Project	IEEE 802.16 Broadband Wireless Access Working Group < http://ieee802.org/16 >
Title	Editorial changes to .16e in response to comment 108
Date Submitted	2005-09-07
Source(s)	Masoud Olfat (Sprint Nextel), Peiying Zhu (Nortel) Charlie Zhang (Nokia)
Re:	IEEE P802.16e/D10
Abstract	This is a consensus reply comment to .16e in order to fix the
Purpose	Discuss and approve.
Notice	This document has been prepared to assist IEEE 802.16. It is offered as a basis for discussion and is not binding on the contributing individual(s) or organization(s). The material in this document is subject to change in form and content after further study. The contributor(s) reserve(s) the right to add, amend or withdraw material contained herein.
Release	The contributor grants a free, irrevocable license to the IEEE to incorporate material contained in this contribution, and any modifications thereof, in the creation of an IEEE Standards publication; to copyright in the IEEE's name any IEEE Standards publication even though it may include portions of this contribution; and at the IEEE's sole discretion to permit others to reproduce in whole or in part the resulting IEEE Standards publication. The contr

Figure 230a – Post Processing CINR for MIMO Region

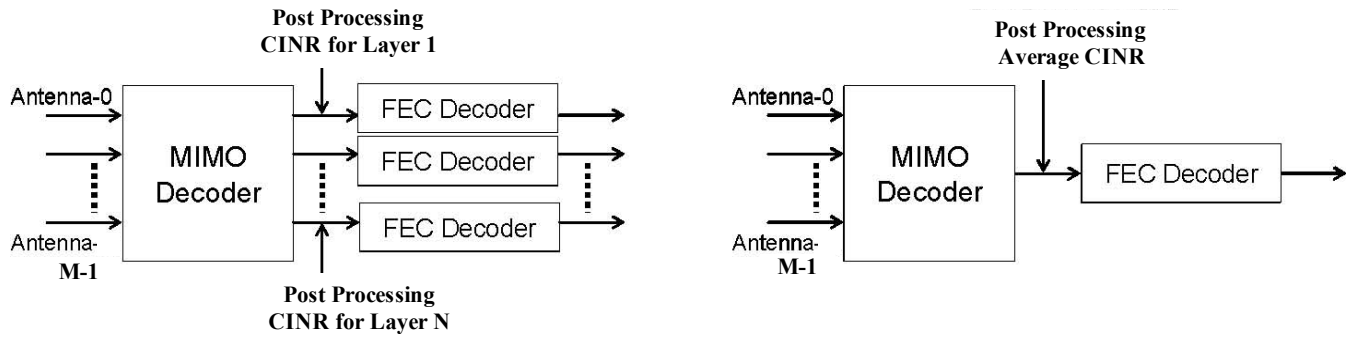
[Insert following text at the beginning of section 8.4.5.4.10.1]:

MIMO capable MS shall measure post processing CINR for each individual layers as shown in Figure 230a. When the FAST_FEEDBACK subheader Feedback Type field is "00", the MS shall report the post processing average CINR (Avg_CINR), as defined in (106a) below. When BS requests MS feedback through CQICH_Alloc_IE() or CQICH_Enhanced_Alloc_IE() with '00' feedback_type field, MS shall report Avg_CINR or individual layer CINR as described in 8.4.5.4.12 and 8.4.5.4.15

where $C(d,y|H)$ is the receiver-constrained mutual information conditioned on knowing the channel knowledge. Note that d is the transmitted signal, y is the post-processing receive signal and H is the channel matrix between transmit and receive antennas. For LMMSE receiver, the individual post-detector-processing signal to noise ratios are given as $\text{CINR}_1, \dots, \text{CINR}_N$, as shown in Figure
